INTERNATIONAL MARITIME ORGANIZATION

MSC.1/Circ.1510
5 June 2015

AMENDMENT TO THE UNIFIED INTERPRETATIONS OF SOLAS CHAPTER II-2, THE FSS CODE, THE FTP CODE AND RELATED FIRE TEST PROCEDURES (MSC/CIRC.1120)

Figure 3

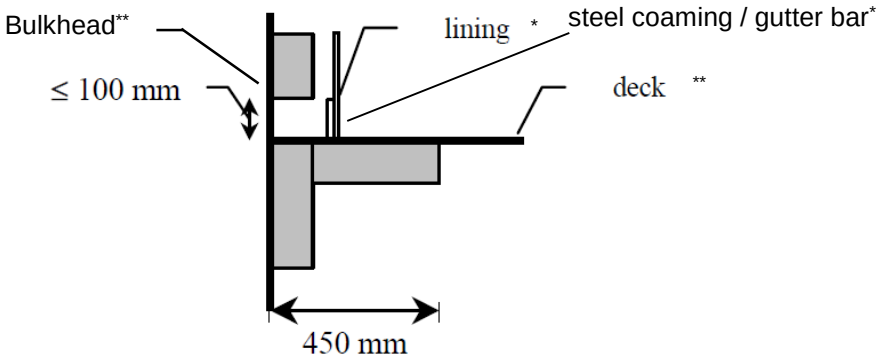
Figure 3 in the appendix of the Unified interpretations for typical arrangements for prevention of heat transmission at intersections and terminal points of insulation of decks and/or bulkheads, is amended as follows.

***Note:**
d = Depth of stiffener on girder.

* Lining and steel coaming/gutter bar are for accommodation spaces only.
** For the purpose of figure 3, bulkhead and deck are of steel construction only.
